Report of Change and Summary of 50.54(q) Analysis – Emergency Plan Implementing Procedure 5.7.6, Revision 69

Emergency Plan Implementing Procedure 5.7.6, Revision 69

EMERGENCY PLAN IMPLEMENTING PROCEDURE

NOTIFICATION

ATTACHMENT 3 OFF-SITE NOTIFICATION FROM EOF FLOWCHART (REFERENCE USE)

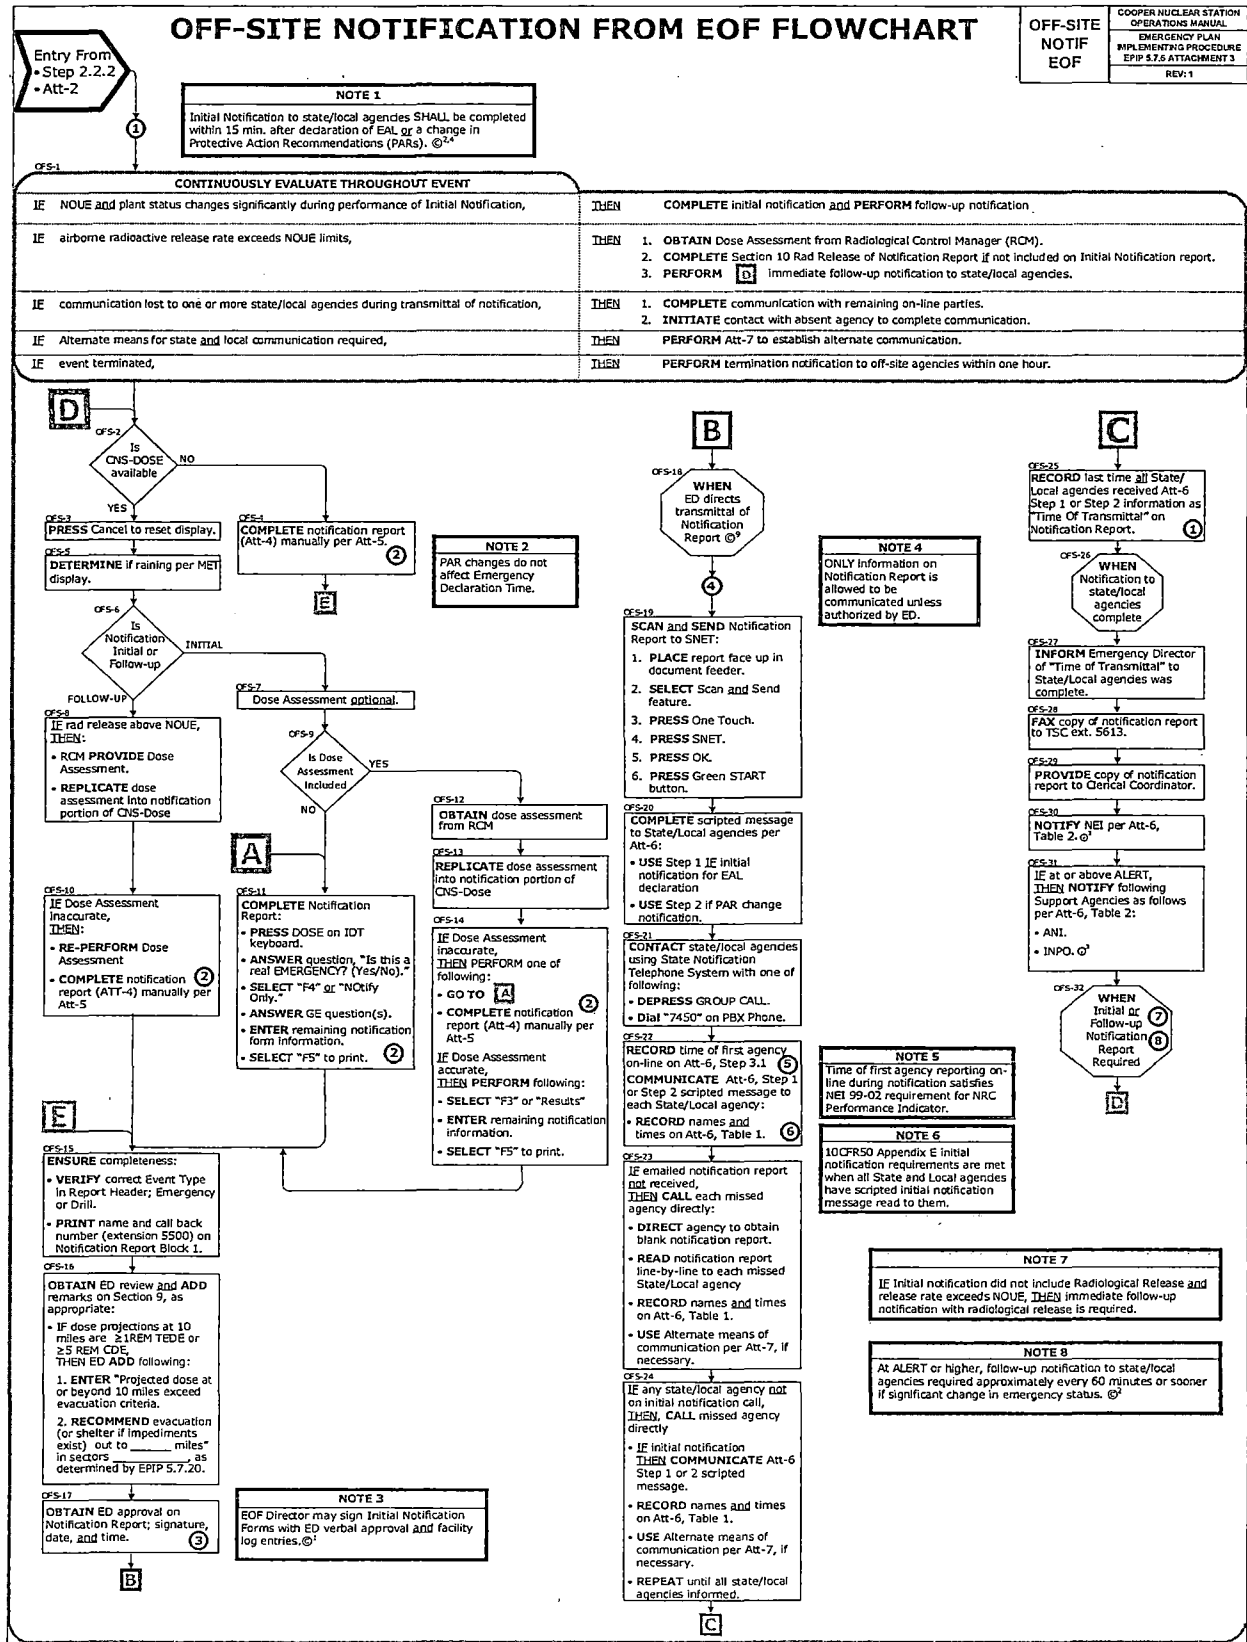
Emergency Plan Implementing Procedure (EPIP) 5.7.6, Attachment 1 and 3 flowcharts, were revised (boxes SC-14 and OFS-14) to add steps for completing the notification. Also the EPIP had previously allowed the user to inappropriately skip Step 3 of Attachment 5 for recording meteorological conditions and release status information when completing the notification report. This step was inadvertently omitted during a previous rewrite of the procedure and has been corrected and again is a requirement for completing the notification with CNS-DOSE unavailable.
